CITY OF ISSAQUAH MAJOR DEVELOPMENT REVIEW TEAM

STAFF REPORT – 12 September 2011

- File No.:** SEP11-00002
- Project:** Issaquah Highlands, Block 23 Steep Slope Hazard Critical Area Study
- Applicant:** Mr. Tom Neubauer
Block 24 LLC
375 118th Ave. SE, Suite 118
Bellevue, WA 98005

- Request:** To approve the Steep Slope Hazard Critical Area Study in order to define a created steep slope within the proposed project site and reduce steep slope critical area buffer impacting the project site, known as the Issaquah Highlands Block 23. The proposed steep slope buffer reduction is from 50 feet to 0 feet as measured from the toe of slope.

Conceptual Wall Detail - Critical Area Study
Issaquah Highlands - Block 23
Issaquah, Washington

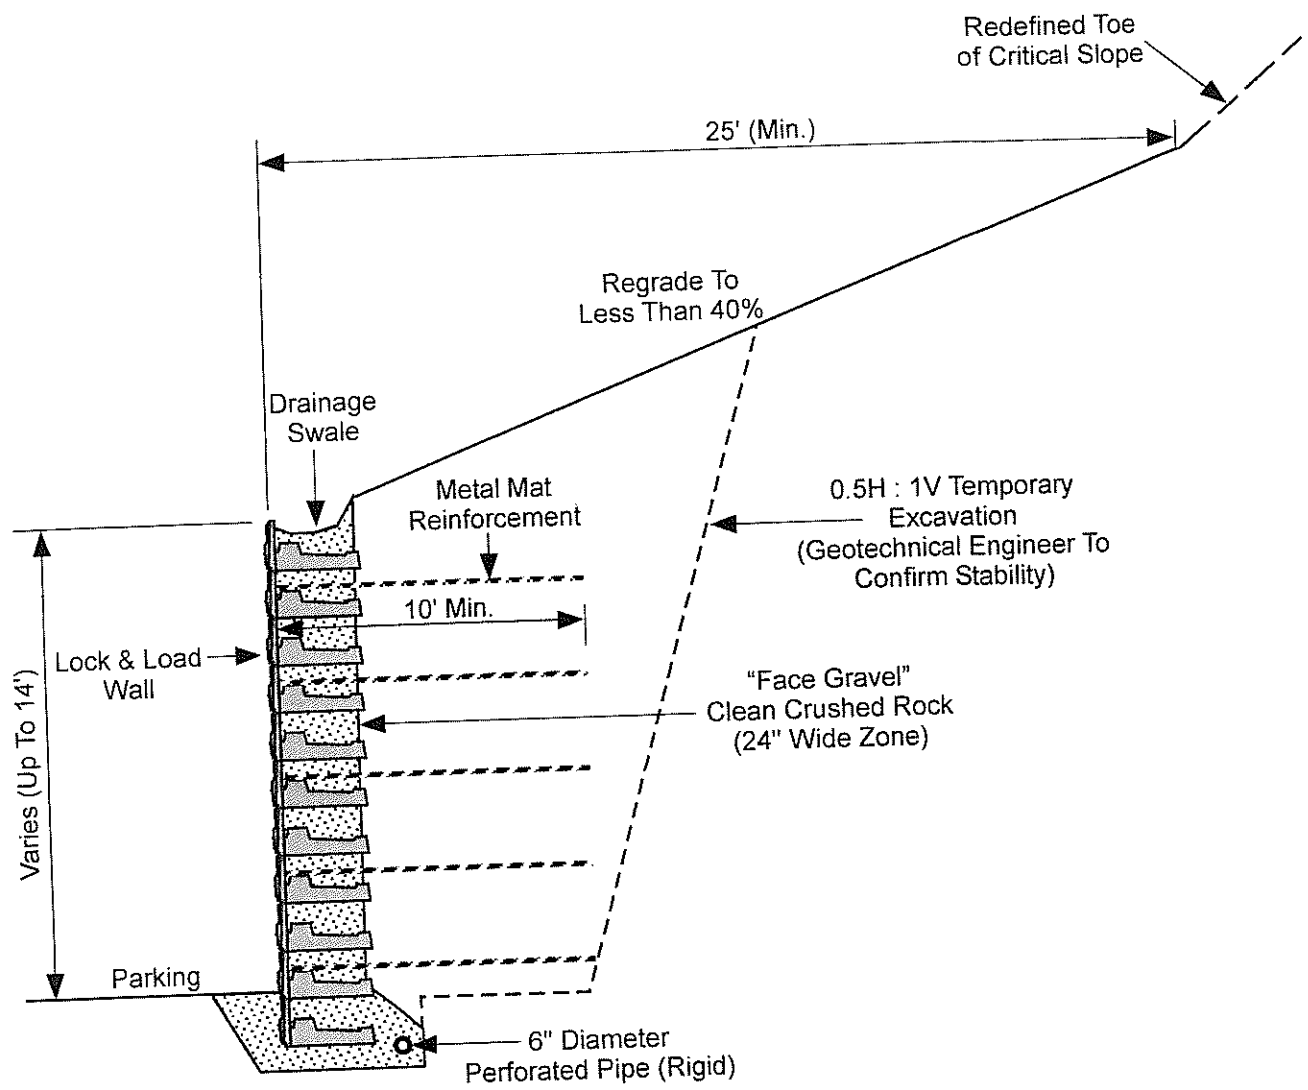
1. The toe of the slope shall be defined as the point at which the slope remains equal to or in excess of forty (40) percent (minimum of 25-feet behind the face of wall), see **Figures 2 and 3**. A 10-foot buffer from the toe of slope and a 15-foot BSBL (occupied structures) shall apply.
